# PRODUCT CHANGE NOTIFICATION

### Select SRN Series Semi-shielded Power Inductors and SRP Series Shielded Power Inductors

#### Carrier Tape and Reel Temporary Change to Alternate Supplier

IC22077

### 2.1 Comparison of appearance

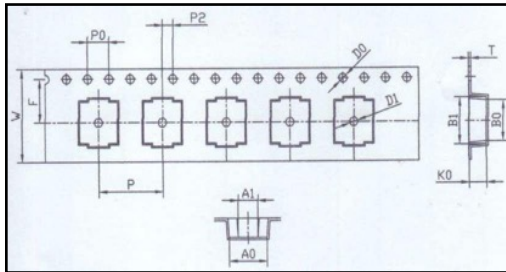
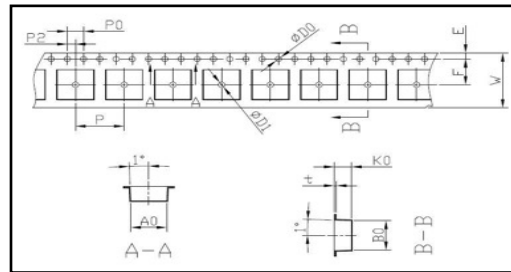
Series	Type	Appearance	Difference
SRN5020TA, SRN5040TA, SRN6045TA	Original		<b>Structure of pocket:</b> Larger radius corner <b>Color:</b> Transparent, slightly white
	Temporary		<b>Structure of pocket:</b> Right angle corner <b>Color:</b> Transparent
SRP4020TA, SRP4012TA	Original		<b>Structure of pocket:</b> Stepped corner <b>Color:</b> Transparent, slightly white
	Temporary		<b>Structure of pocket:</b> Right angle corner <b>Color:</b> Transparent, slightly white
SRP7028A, SRP7028AA, SRP6030VA	Original		<b>Structure of pocket:</b> Stepped corner <b>Color:</b> Transparent, slightly white
	Temporary		<b>Structure of pocket:</b> Stepped corner <b>Color:</b> Transparent
